Comments on #SDP-26-0004 - Planning & Zoning: Site Development Plan

Application Number: #SDP-26-0004
Application Type: Site Development Plan
Date: August 12, 2026
Address: 705 S MAIN ST, ROLESVILLE, NC 27571
Parcel: 1758574058

WALLBROOK SHOPPES (LOT 5C)

Town of Rolesville Project No. SDP 26-0004

- 4 Jacqueline Thompson

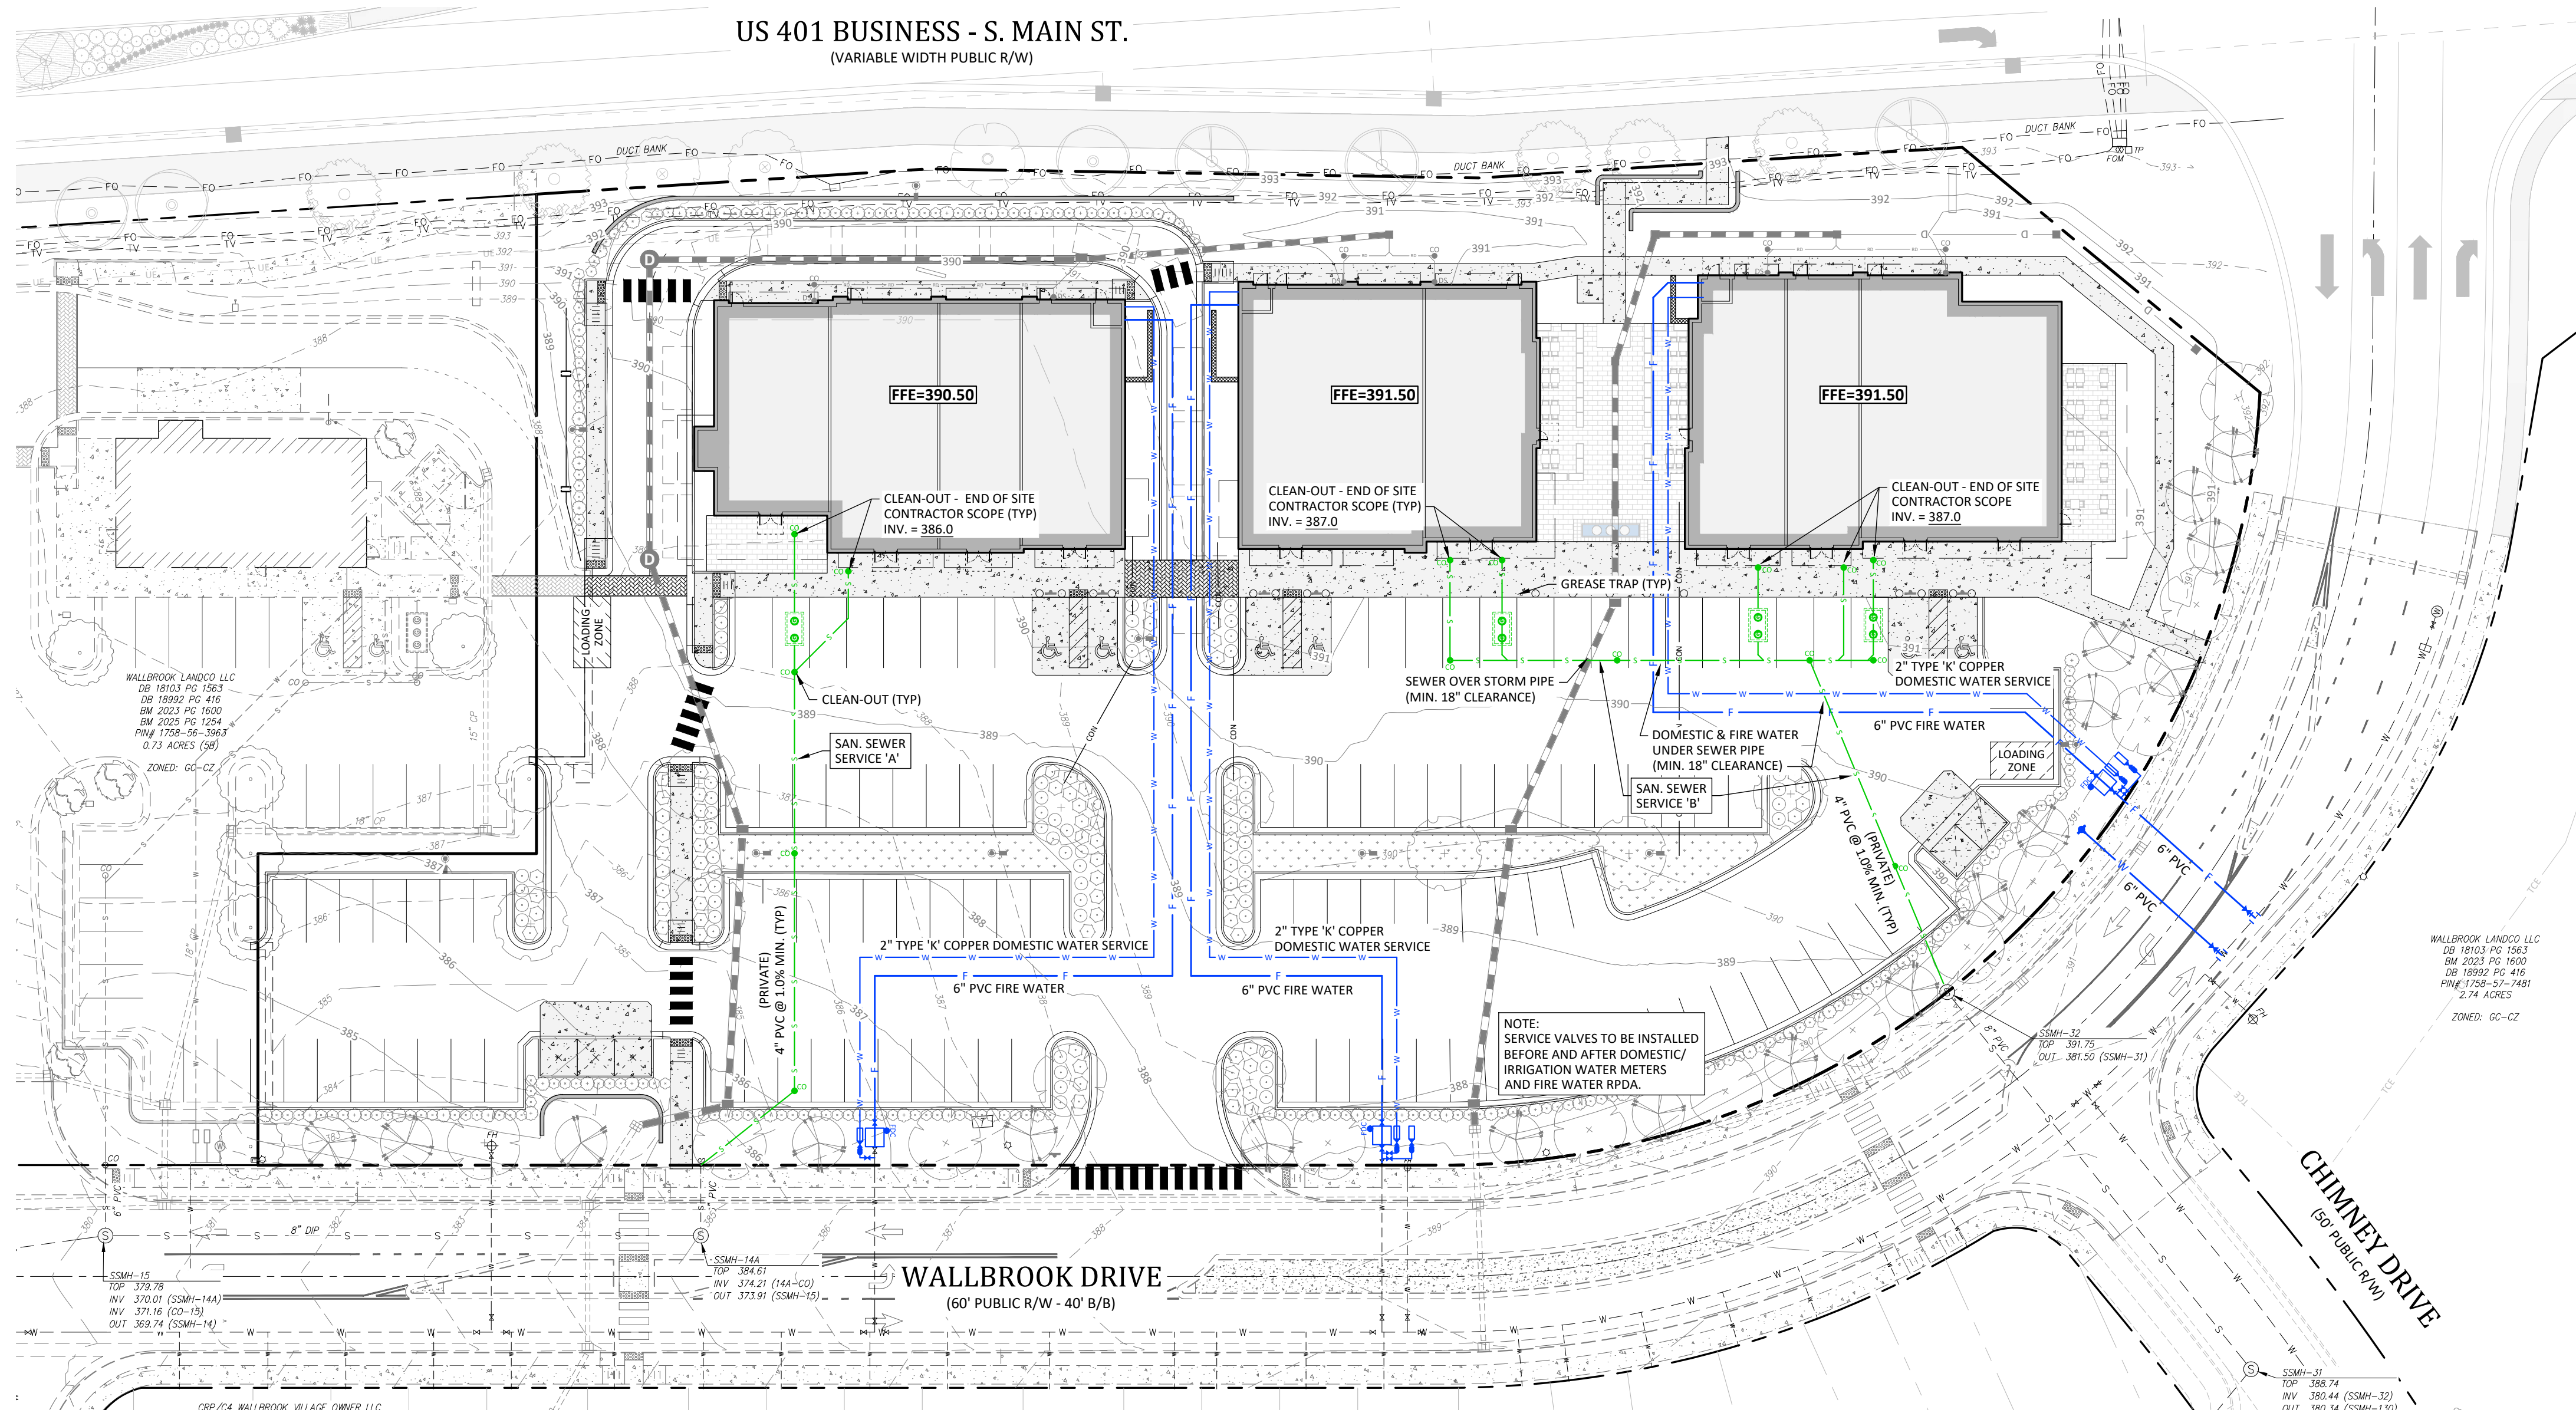
Please include a typical section/detail for bicycle parking with a rack to meet the requirements of LDO Section 6.4.7
- 5 Jacqueline Thompson

Please include the easement width in the label.
- 6 Jacqueline Thompson

REQUIRED VEGETATION PLAN
WALLBROOK SHOPPES (LOT 5C)

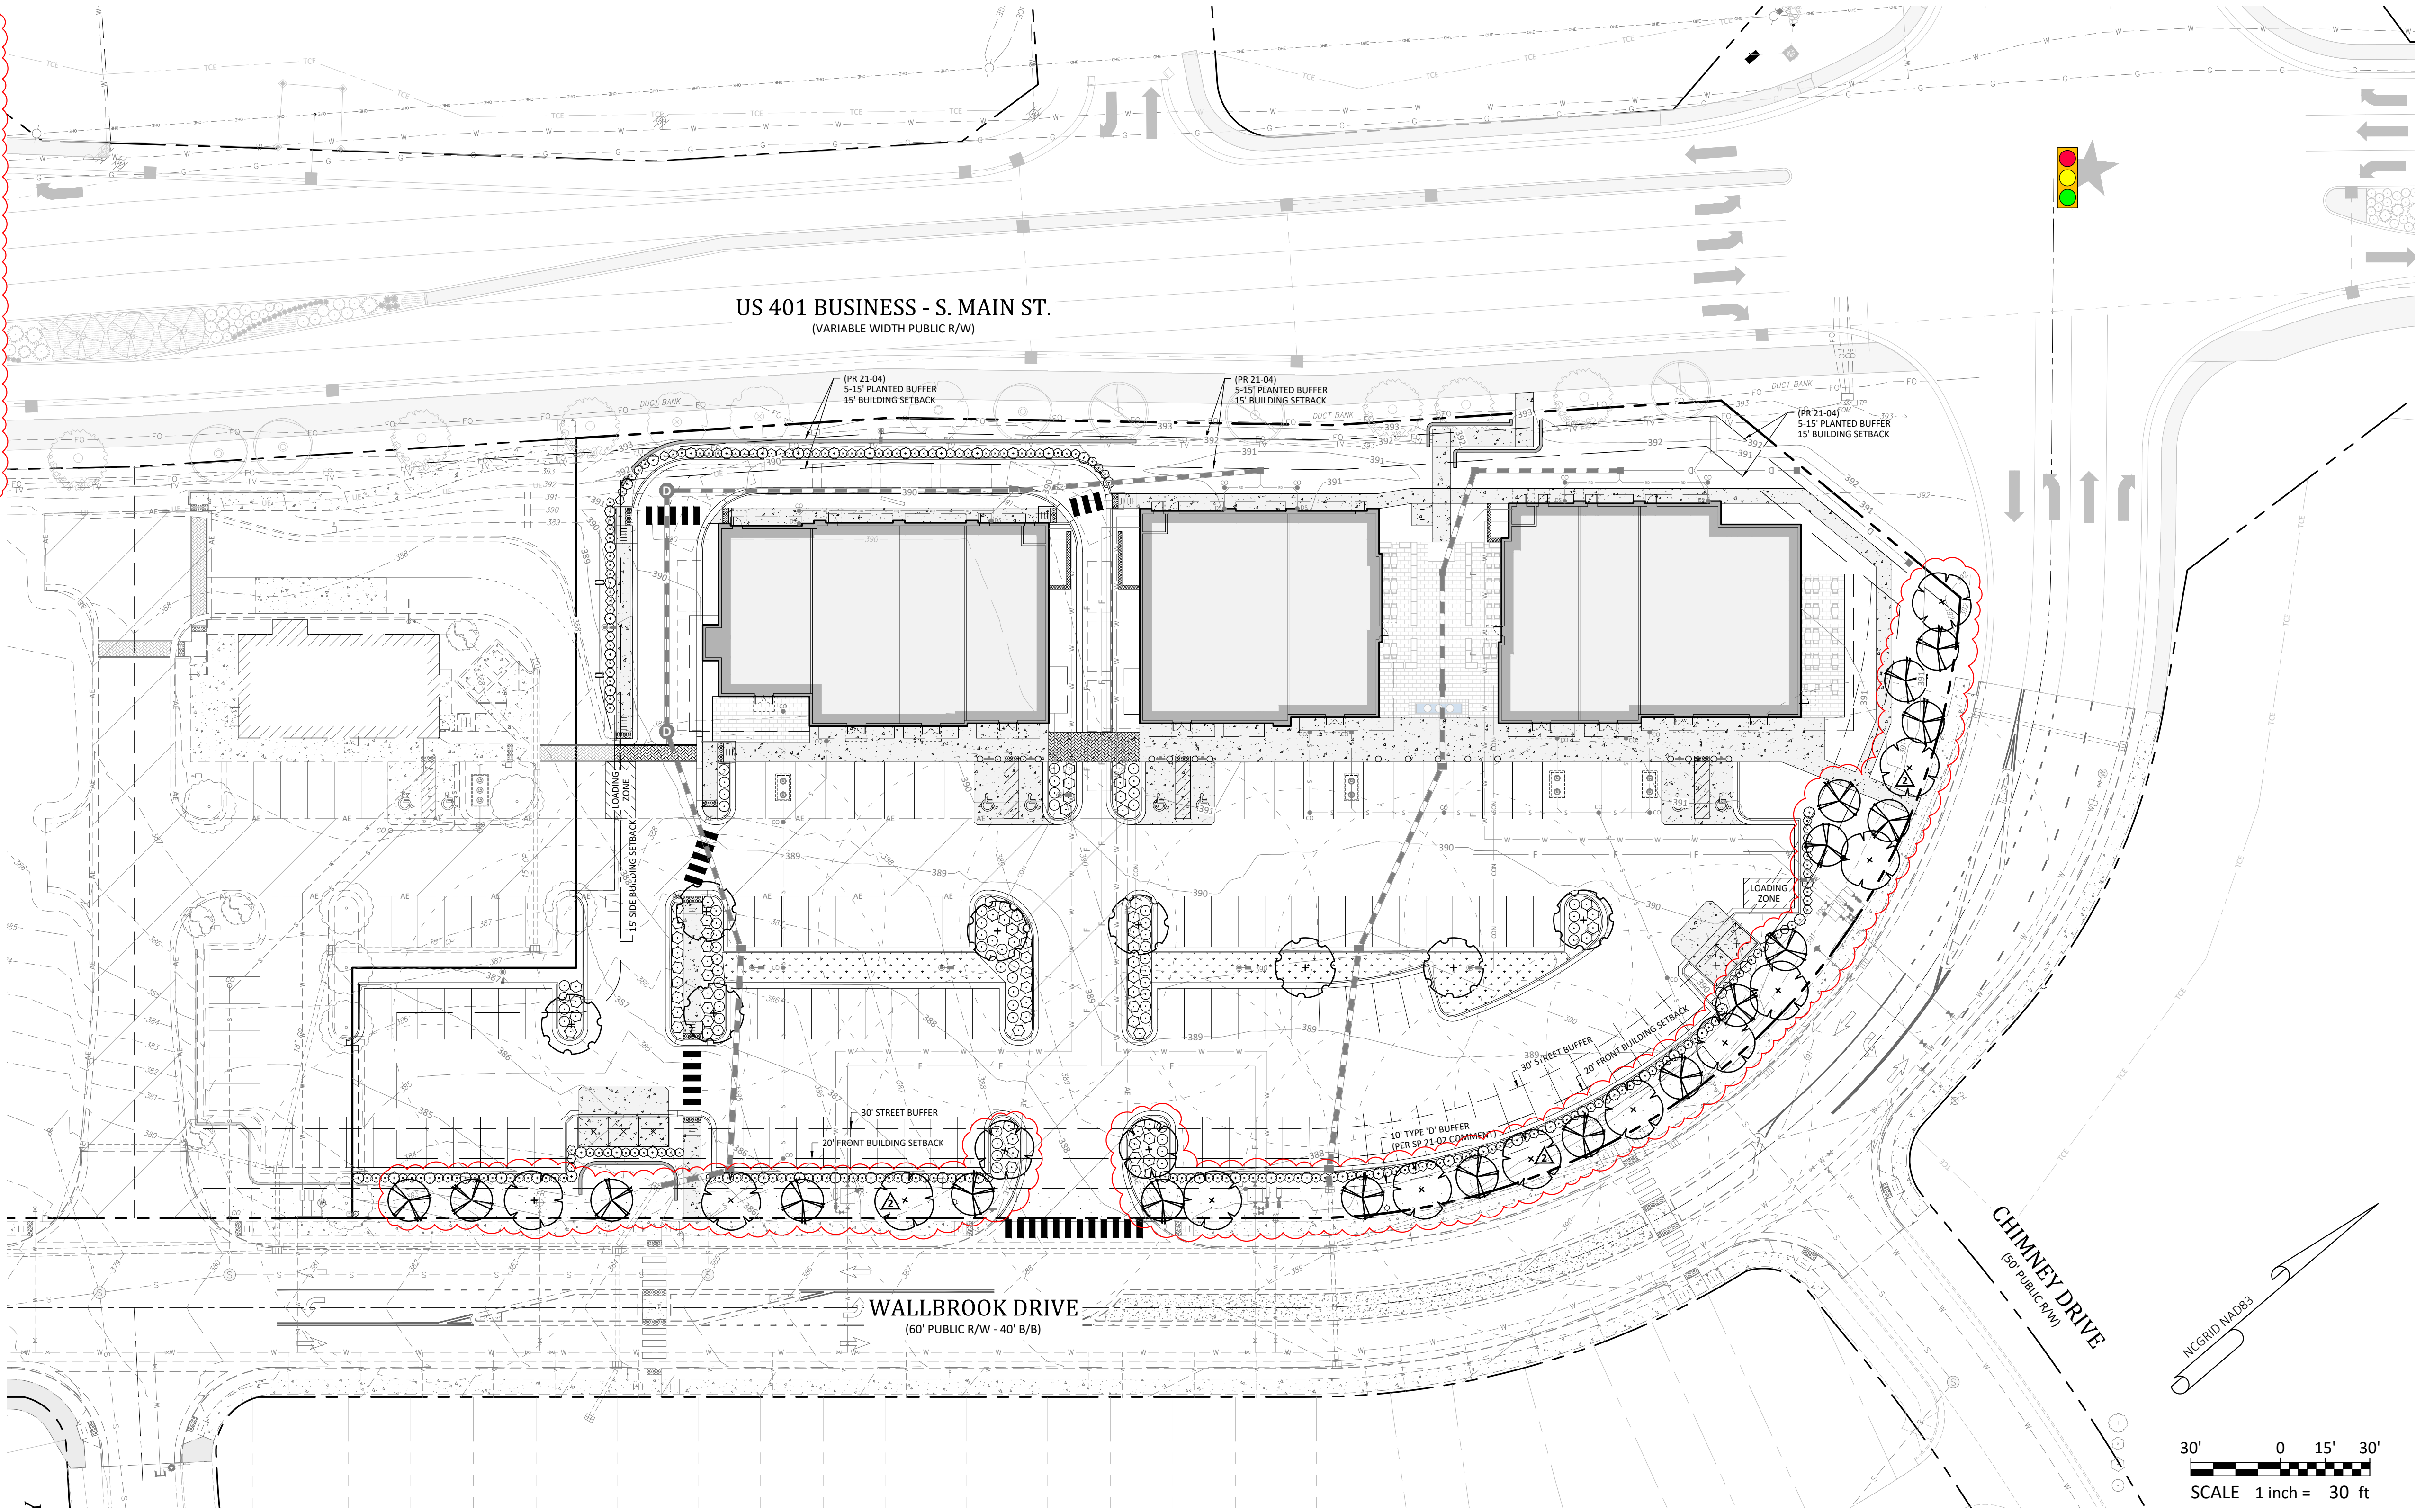
REPEAT - Please review the tree location - per LDO Section 6.2.5.B, no street tree shall be planted closer than 10' from any fire hydrant.
